# Access Compliance Report

## Public Rights-of-Way

Intersection ID: 2934	Main Street: CHINQUAPIN_CT	Cross Street: LADY_BANK_DR	Location: NE
ADA ID: F39ED068D3FB	Ramp Type: BlendTrans1	Initial Pass/Fail: Fail	Overall Compliance: No
		Severity Score: 12.5

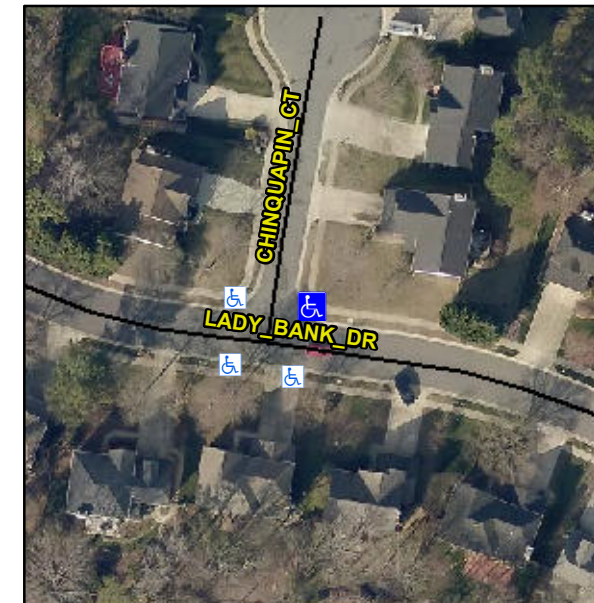
**CURB UNMODIFIED**

**Not Found, R304.5.3**

Compliance	Description	Data	Compliance	Description	Data
N/A	Ramp Length (in)	44.0	Yes	BlendTrans Slope (%)	3.7
Yes	Ramp Width (in)	48.0	No	BlendTrans XSlope (%)	5.7
N/A	Flare Type LT	N/A	N/A	Flare Type RT	N/A
N/A	Flare Slope LT (%)	N/A	N/A	Flare Slope RT (%)	N/A
N/A	Flare Traversable LT?	N/A	N/A	Flare Traversable RT?	N/A
N/A	Landing Length (in)	N/A	N/A	DWS Provided?	N/A
N/A	Landing Width (in)	N/A	N/A	DWS Contrast?	N/A
N/A	Landing Slope (%)	N/A	N/A	DWS Length (in)	N/A
N/A	Landing X Slope (%)	N/A	N/A	DWS Full Width?	N/A
N/A	Landing Curb? (Y/N)	N/A	N/A	DWS Offset (in)	N/A
N/A	Shared Landing?	N/A			
N/A	Gutter Ponding?	N/A	N/A	Gutter Slope (%)	N/A
N/A	Gutter Lip Ht (in)	N/A	N/A	Gutter X Slope (%)	N/A
N/A	Painted X Walk1?	No	N/A	Painted X Walk2?	No
	X Walk 1 Direction	To W		X Walk 2 Direction	To S
	X Walk 1 Width (in)	N/A		X Walk 2 Width (in)	N/A
	X Walk 1 Slope (%)	1.0		X Walk 2 Slope (%)	2.4
	X Walk 1 X Slope (%)	2.7		X Walk 2 X Slope (%)	3.4

N/A	Ramp inside XWalk1?	N/A	N/A	Ramp inside XWalk2?	N/A
	Road Slope (%)	6.5		Clear Space?	N/A
	Road X Slope (%)	1.3	N/A	Clear Space to XWalk (in)	N/A
N/A	Any Obstructions?	N/A	N/A	Storm Grate/Utility Hazard?	N/A
	Obstruction Type			Storm Grate/Utility Type	
		N/A			N/A
			Yes	Surface Condition? (G/P)	Good
			No	Curb Slope (%)	29.2

**Remove & Replace Curb Ramp With Two New Directional Ramps or Equivalent.**
